In-vehicle battery durability e-HDVs

Open Items

Elena Paffumi, Gian-Luca Patrone
EVE IWG 70th , web-meeting,
May 7th-8th , 2024

e-HDV's tests open questions: acceleration, road grading/slope ✓ ?

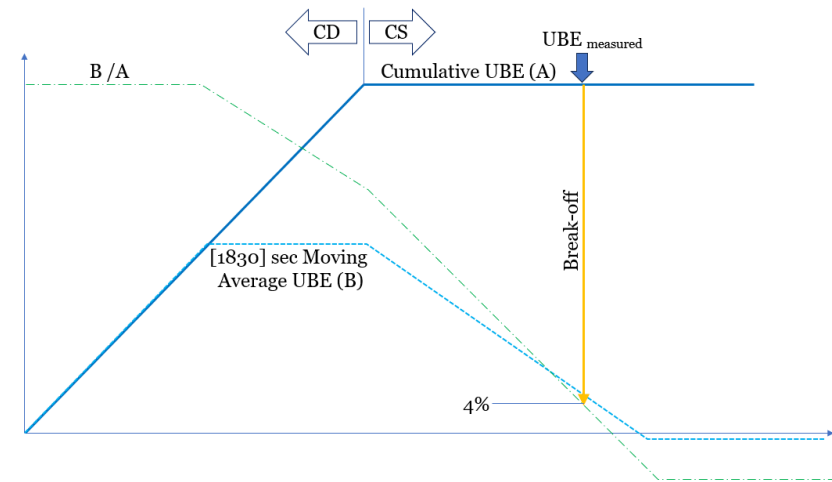
to improve practical test execution, propose to apply same conditions as RDE requirement means that “the cumulative elevation gain” shall be less than 1,200m / 100km

- Road grading/slope, accuracy on UBE to add?
- Effect of the acceleration to the target speed with road grading/slope
- Effect on the last portion of the test: grading, payload, speed, power request ... near the break-off point

- Proposal to apply same conditions as RDE requirement on all the route/test: “the cumulative elevation gain” shall be less than 1,200m / 100km
- Effect on the last portion of the test: slope at the end of the test to be reported
- No conditions for method 1b as per method 1a

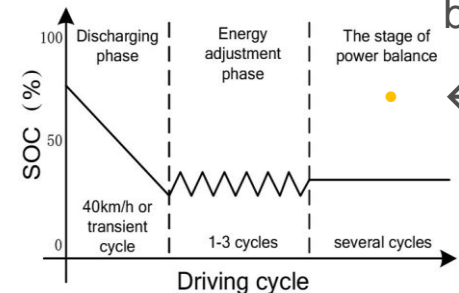
Japan: at least 1500sec ?
 JE05 : 1830 sec
 WLTP 4 : 1800 sec
 WLTP 3 : 1477 sec

Japan: 4 per cent of cumulative UBE

Method 1a Discharge by standard average speed on a test track

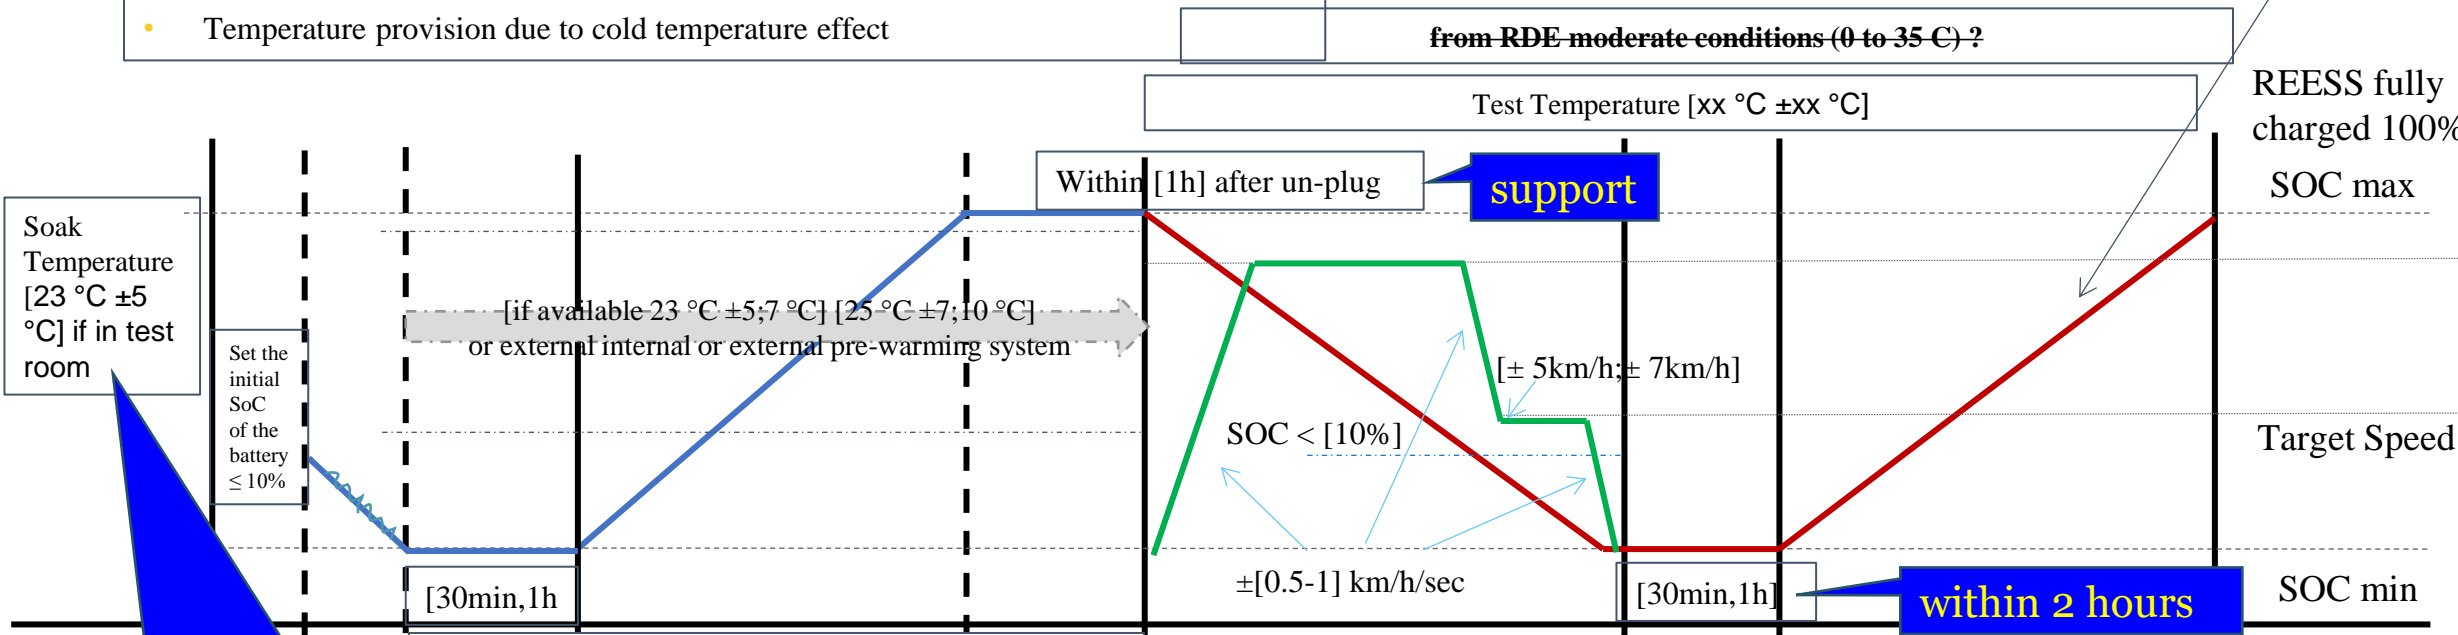
- Range of speed per category per region track
- To leave open the speed for the test and prescribe only the target speed in the last part of the test for which a speed tolerance will be applied
- The last part of the test starts when the SOC < [10%] (to be verified)
- Speed tolerance in last test segment [$\pm 5\text{km/h}; \pm 7\text{km/h}$]
- The acceleration/deceleration during vehicle speed change shall be smooth and accomplished within the range $\pm[0.5-1]\text{ km/h/sec}$
- End of discharge: break-off criterion
- Temperature provision due to cold temperature effect

from RDE moderate conditions (0 to 35 °C)?

[if available 23 °C ±5; 7 °C] [25 °C ±7; 10 °C] or external internal or external pre-warming system

support

Japan: 23 or 25 +/-5 = 18 ~ 30 C as an option, wider temperature range is acceptable without any correction if manufacture allows.

not able to support

- Agreed as reported in the following slides ✓
- Soak and charge temperature [$25\text{ °C} \pm 5\text{ °C}$] if in a test room ✓ agreed
- Soak and charge for a minimum of 6 hours and a maximum of 36 hours ✓ agreed
- ~~With a C-rate in the range of $[C/6\text{ or less, } C/2]$ to remove this requirement since there is already the requirement on the speed~~ ✓
- If on-board system are used to complete the REESS depleting due to safety reason(method 1a and 1b) , c-rate? (Typically is automatically set). Criterion for stopping the test?
- To revise the text about having the same boundary conditions in certification and ISC, if declaring of UBE is allowed

Method 1b Discharge by driving on the road with average speed

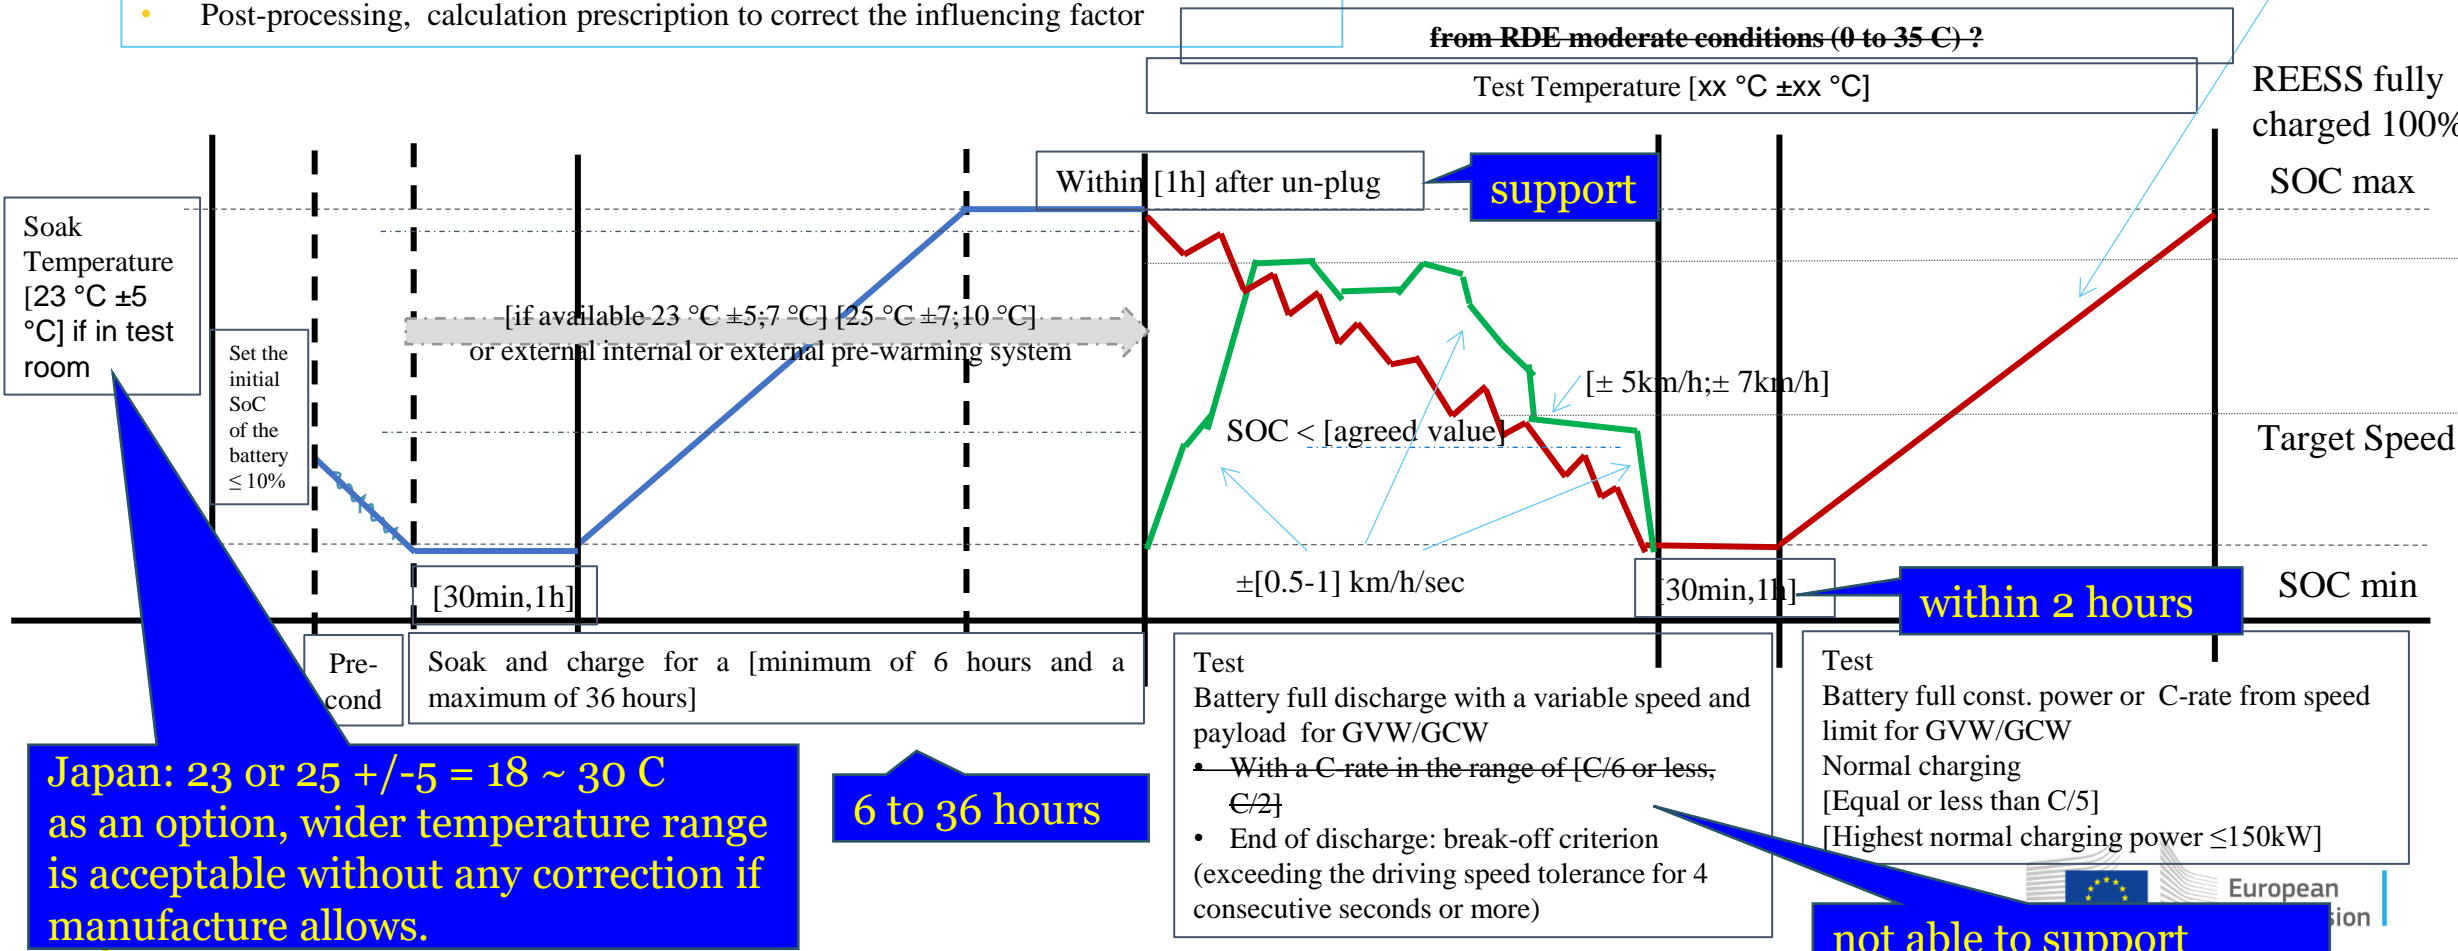
- Range of on-road speed per category per region
- To leave open the speed for the test
- The last part of the test starts with a given SOC level
- Some agreement with local regional authority for SOC minimum level and test
- Same route as type approval or different in accordance with regional authority
- If same routes is used, different provision on minimum SOC level and test
- Speed tolerance? in last test segment ?
- The acceleration/deceleration during speed change shall be as smooth as possible in relation to traffic conditions and safety of driving
- Post-processing, calculation prescription to correct the influencing factor

Japan: 23 or 25 +/-5 = 18 ~ 30 C as an option, wider temperature range is acceptable without any correction if manufacture allows.

Method 2 bidirectional charging system available

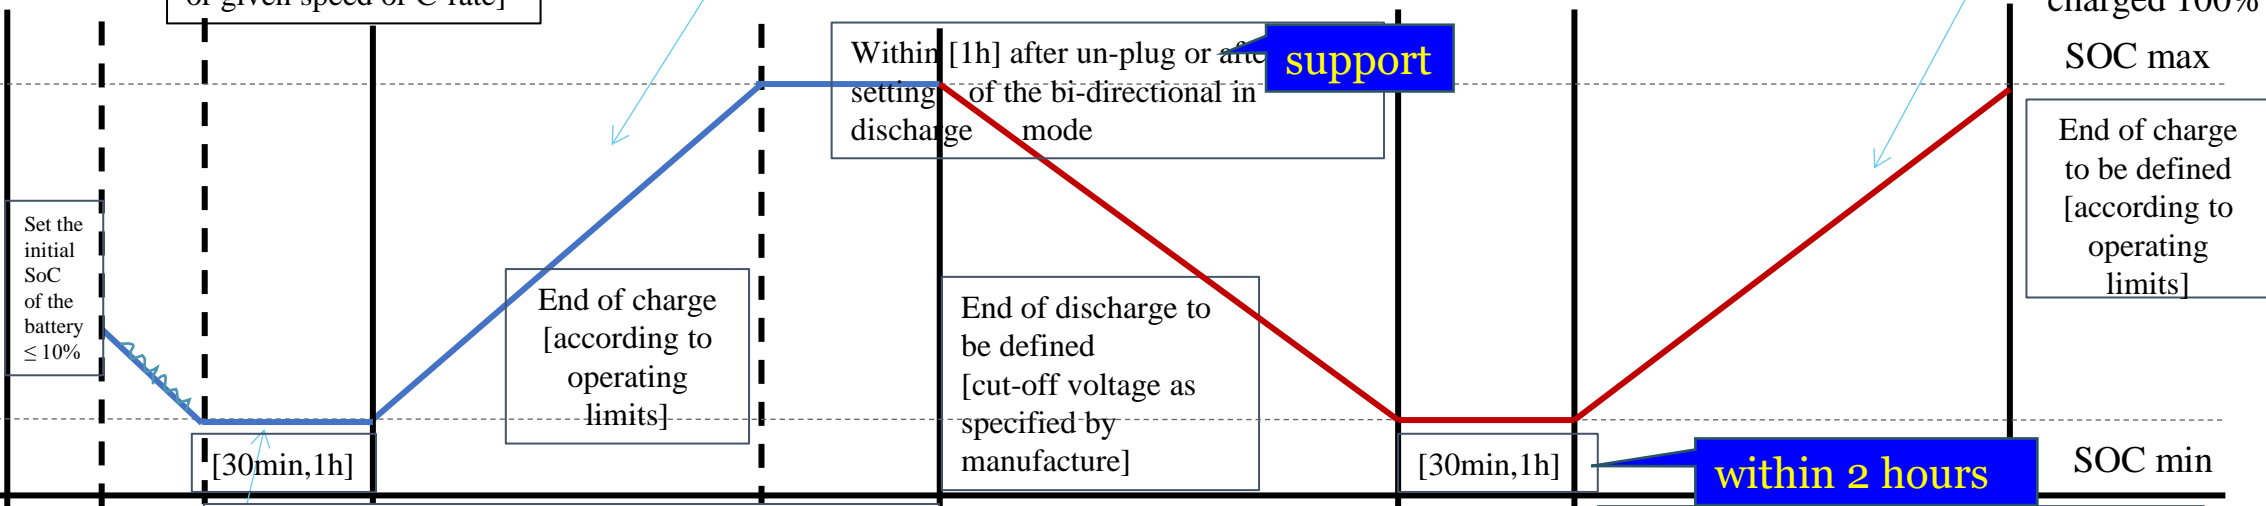
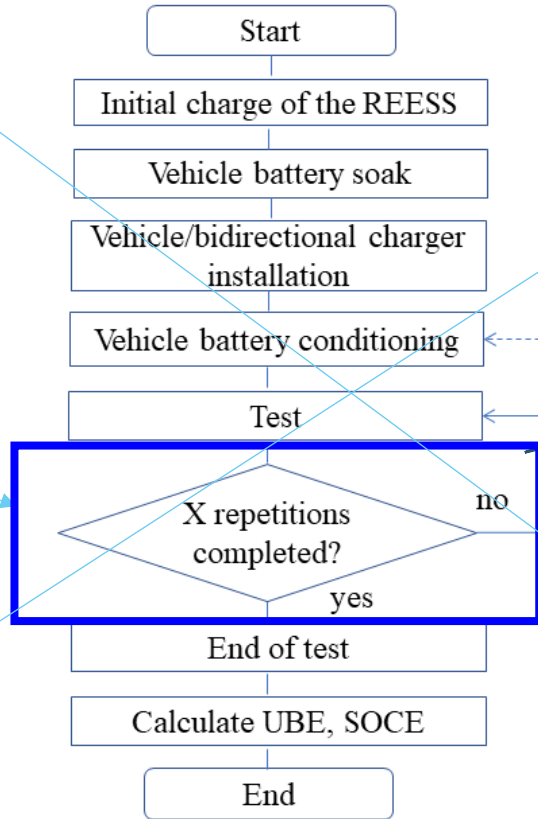
Japan: 23 or 25 +/- 5 = 18 ~ 30 C as an option, wider temperature range is acceptable without any correction if manufacture allows.

within 0 ~ 35 C

follow manufacture recommendation

not able to support
